<b>Title of Change:</b>	New Tube Design for APM16/ASPM16.
<b>Effective date:</b>	11 Nov 2022
<b>Contact information:</b>	Contact your local onsemi Sales Office or <a href="mailto:Peter.Lee@onsemi.com">Peter.Lee@onsemi.com</a>
<b>Type of notification:</b>	This Product Bulletin is for notification purposes only. onsemi will proceed with implementation of this change upon publication of this Product Bulletin.
<b>Change Category:</b>	This is a packing tube design change
<b>Change Sub-Category(s):</b>	Packing Tube design change

# Tube Design Dimension

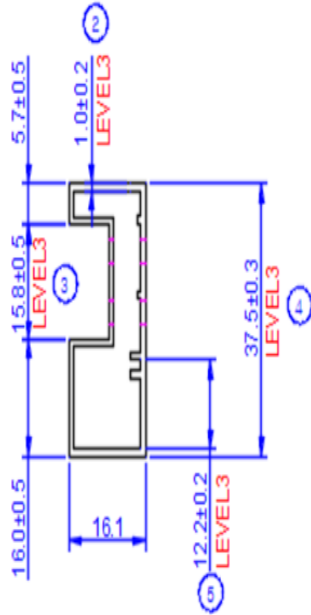
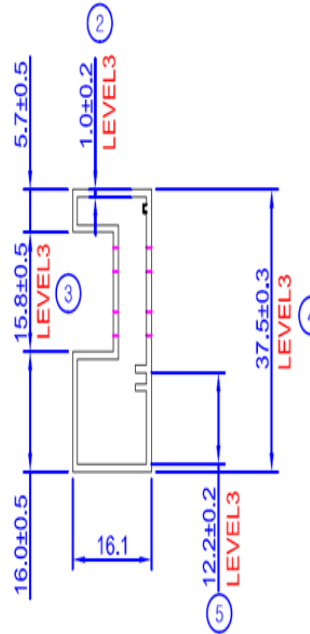
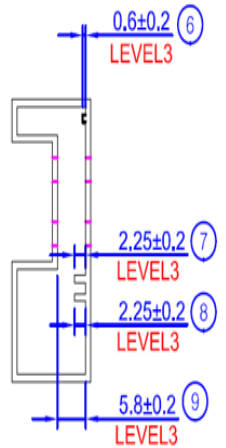
Customer reported that current tube caused visual scratch on the DBC. New tube design to reduce potential for visual scratches on DBC surface.

- Minimum movement (shake) of the product within tube
- Visual scratch of DBC surface
- No quality issue (Only visual scratch that does not impact the performance and reliability)

- Minimum movement (shake) of the product within tube
- Can remove the visual scratch of DBC surface than that of previous tube
- No quality issue
